**Department of Energy**  
Washington, DC 20585

# ENERGY STAR® for Windows, Doors, and Skylights

## Eligibility Criteria *Energy-Efficiency Specification*

### Equivalent Energy Performance Amendment for Windows and Doors

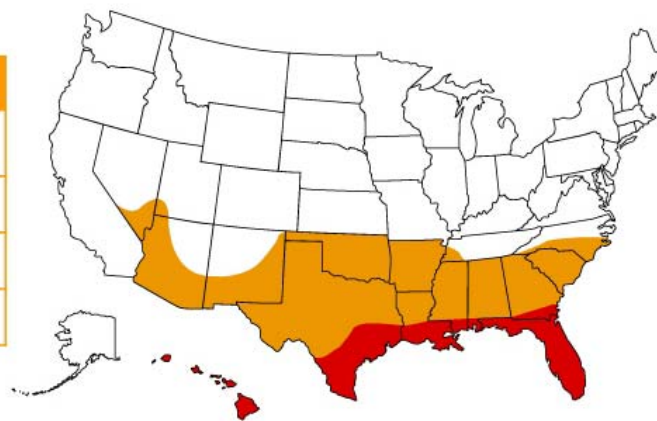
After evaluating stakeholder comments, the Department has decided to amend the qualifying criteria for ENERGY STAR for Windows, Doors, and Skylights to allow windows and doors with energy performance equivalent to the current prescriptive criteria to qualify for ENERGY STAR in the Southern and South Central climate zones, excluding California. This amendment will take effect July 1, 2005.

The performance amendment does not allow for U-Factor and/or SHGC trade-offs in either the Northern or North Central zones. In the Northern zone, the ENERGY STAR U-Factor criterion is set at the same level as the International Energy Conservation Code (IECC) prescriptive requirements and allows no latitude for a trade-off. In the North Central zone the current criteria are close to optimal and therefore allow no trade-off.

The Department is including the Southern zone in this amendment as trade-off solutions are possible. Many impact-resistant hurricane windows using laminated Low-E glass have higher U-Factors but can save equal or more energy with lower SHGCs.

U-Factor	SHGC
Prescriptive	$\leq 0.40$	$\leq 0.40$
Equivalent Performance	$\leq 0.41$	$\leq 0.36$
	$\leq 0.42$	$\leq 0.31$
	$\leq 0.43$	$\leq 0.24$

U-Factor	SHGC
Prescriptive	$\leq 0.65$	$\leq 0.40$
Equivalent Performance	$\leq 0.66$	$\leq 0.39$
	$\leq 0.67$	
	$\leq 0.68$	$\leq 0.38$
	$\leq 0.69$	$\leq 0.37$
	$\leq 0.70$	
	$\leq 0.71$	$\leq 0.36$
	$\leq 0.72$	$\leq 0.35$
	$\leq 0.73$	
	$\leq 0.74$	$\leq 0.34$
	$\leq 0.75$	$\leq 0.33$
